Technical Bulletin

No: ITCM-0619-A

Product 50hz High Speed Xpress Ovens: AXP* (Amana) & MXP* (MenuMaster)

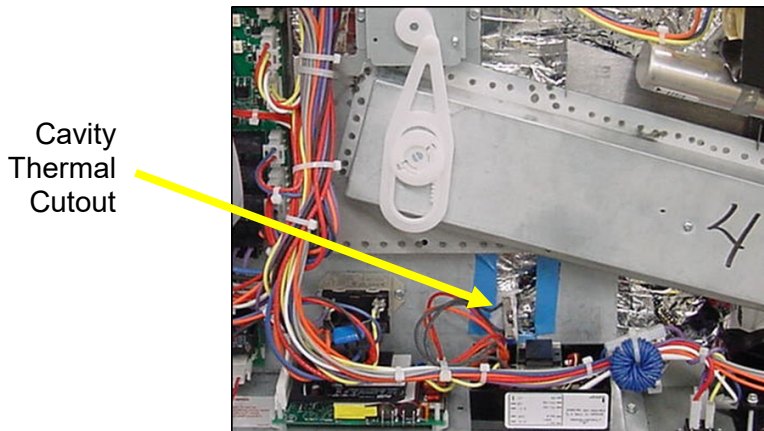
ACP, Inc. has recently received approval from our testing agency, Intertec, the Cavity Thermal Cutout (Part#B5795317) may be removed and safely bypassed should one be found in an open condition with no other oven faults.

1. Cut the connectors off both ends of RD84 (at TCO and Reset Switch Connections)
2. Cut old connector and install new 1/4 Female Spade Connector on red Reset Switch wire)
3. Attach RD93 to new connector on Reset Switch.
